**January 11, 2017**

**Re: Victor Steinbrueck Park**

# Steinbrueck Park

**April 21, 2016****9:00 - 10:30 am****Type**

Figure 3: Connectivity study - Option 1

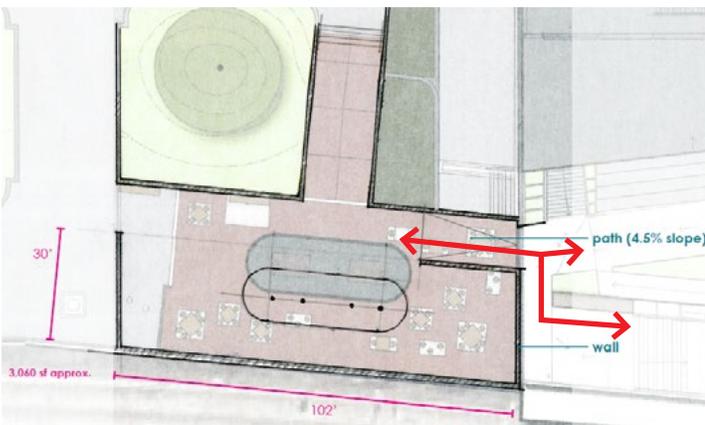
Moving forward the SDC encourages SPR to continue engaging the community on options to make a connection to PC1-N, one that strikes a balance between the unique character of the park and its role in making connections to the Central waterfront for all people – residents and visitors. Initial concept designs show encouraging progress, providing a restrained approach with retention of key features of the 'living room'. The proposals also show an important 'mixing zone' between PC1-N and VSP that provides sufficient room for pedestrians at this important intersection. (see figures 3 & 4)

Figure 3: Proposed waterfront connection without connection to park (above) and with connection to park (below)

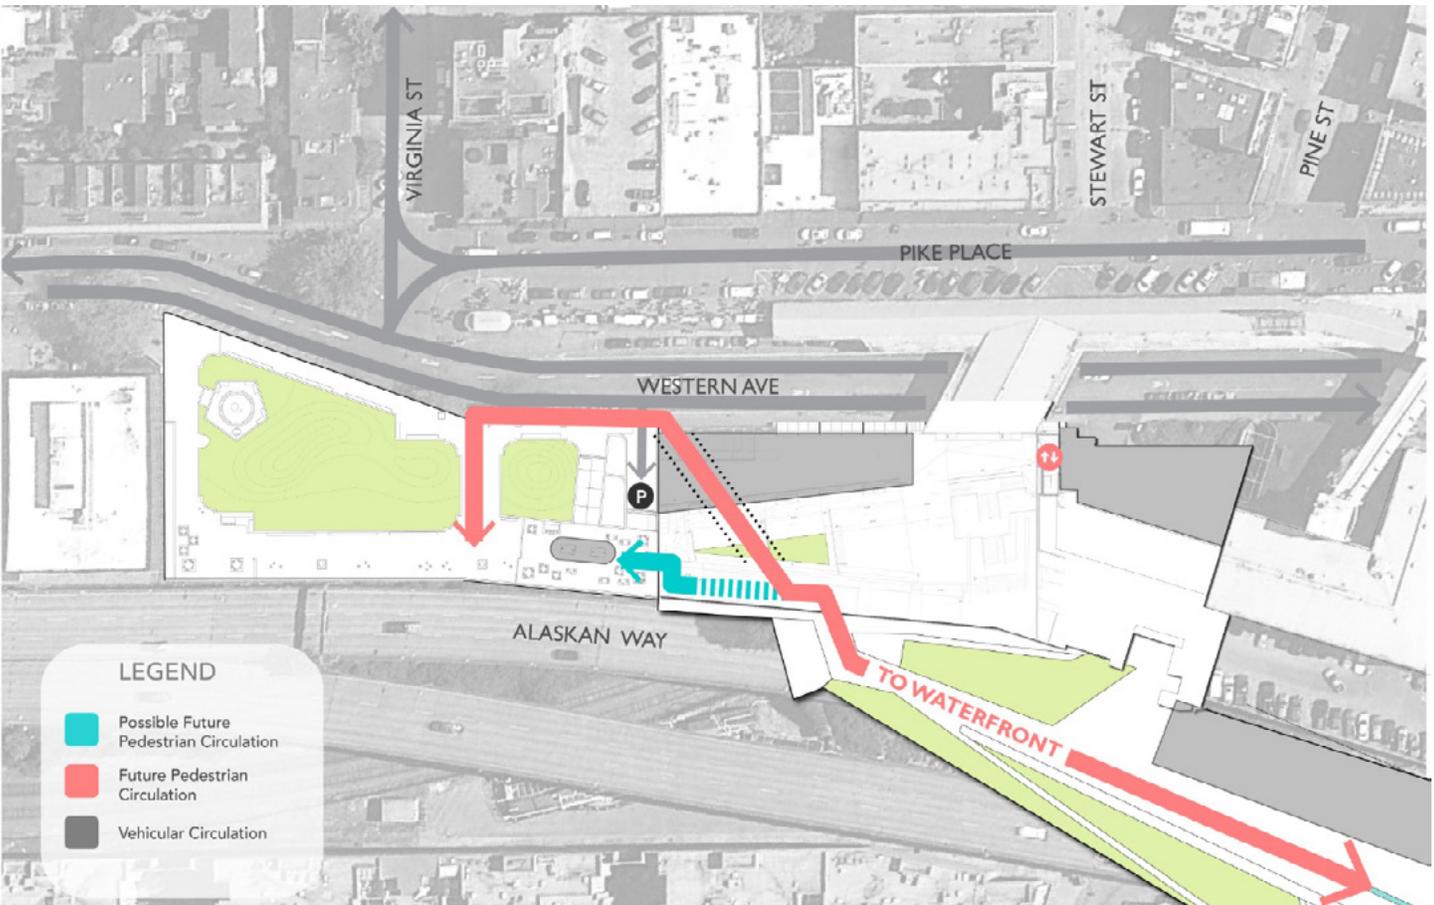
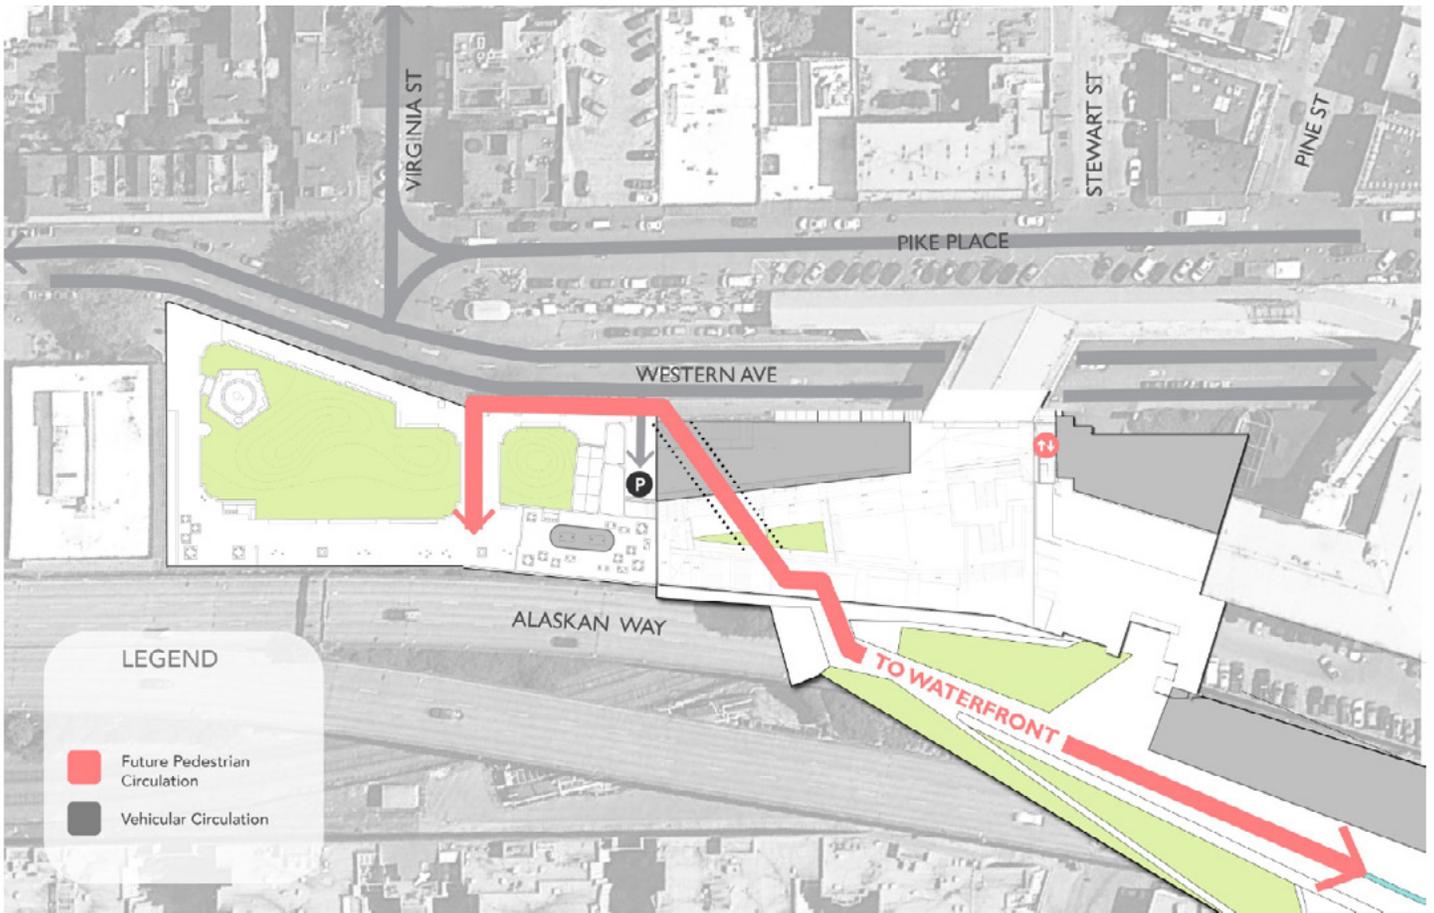
Steinbrueck Park is connected to Pike Place Market along Western Ave and Pike St. Proposed designs include providing connectivity between Steinbrueck Park and the Waterfront along Western Ave. In its current state, Western Ave includes steep, narrow sidewalks that have fallen into disrepair. The updated design also considers a safer, more direct and accessible connection between Steinbrueck Park, Marketfront and onto the Waterfront. If no connection occurs, the proposed design will include a low-lying wall that will separate Steinbrueck Park from the Marketfront and Waterfront projects. See figures 3 and 4 for more detail.

The SDC supports a direct connection between Steinbrueck Park and the Marketfront. To accomplish this, the SDC recommended that the design team continue exploring ways to provide a direct connection without altering the historic aspect of the southwestern edge of the park.

At this meeting, The SDC endorsed the idea of providing a connection between Steinbrueck Park and the adjacent Marketfront and Overlook Walk projects. The Commission recommended the project team provide a connectivity point while preserving the original design intent of the park. The SDC also endorsed the idea of continuing outreach with community members and user groups.
